City of Portland, Maine - Building or Use Permit Application

Proposed Use: 2 Family Dwelling- Repair and Replace front steps	Proposed Project Description: Repair and Replace front steps
---	--

Re: Replacement of two front porches – 144 Spring Street

Detail - 144 Spawny
Arch + stairs to be repaired

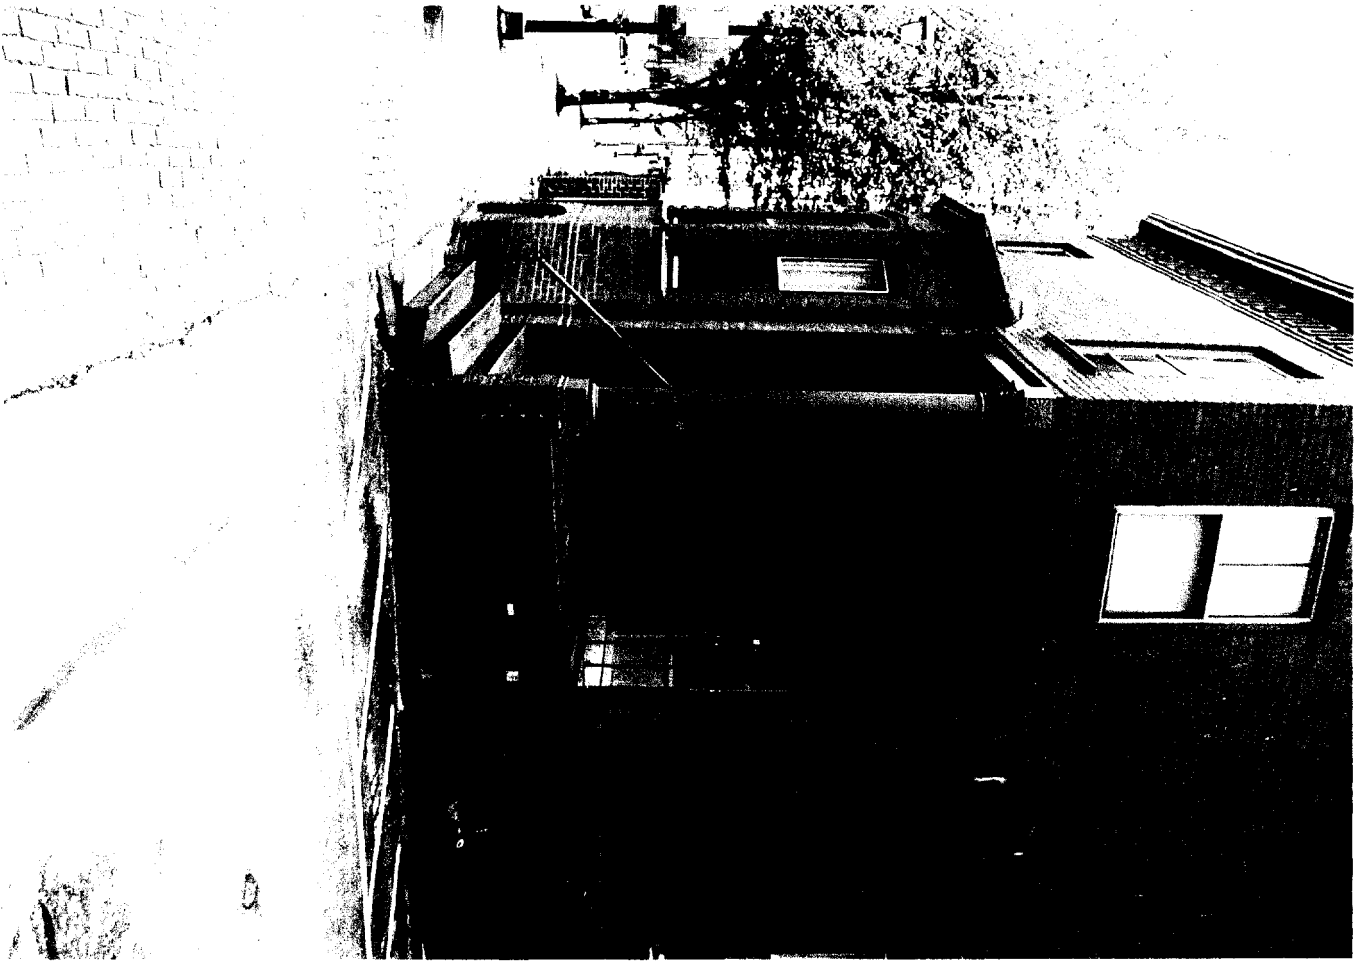
Porch and stair specifications: 142 Spring Street:

Porch and stairs will be replaced using 2x8 PT lumber 16" OC as a frame for the porch.

Frame will be supported on 2 sides (three points) by the existing building. - 2x8 Bolted existing

The fourth point of support will be on an existing piling.

Stairs will terminate on an existing granite slab, which has the approximate (but not identical) rise and run as the stairs to be built.

Porch and stairs will have one railing as per the attached specs.

Porch and stair specifications: 144 Spring Street:

Porch and stairs will be replaced using 2x8 PT lumber 16" OC as a frame for the porch.

Frame will be supported on 2 sides (three points) by the existing building. 2x8

The fourth point of support will be an existing brick column, which also serves as the base for a steel column above.

Stairs will terminate on an existing stone/ concrete slab, which has the approximate (but not identical) run as the stairs to be built. The rise of this slab is approximately 3 inches.

Porch will have one railing as per the attached specs.

Stairs will not have a railing, as per recommendations of Deb Andrews of Historic review committee. Excepting that existing pipe railing may be retained.
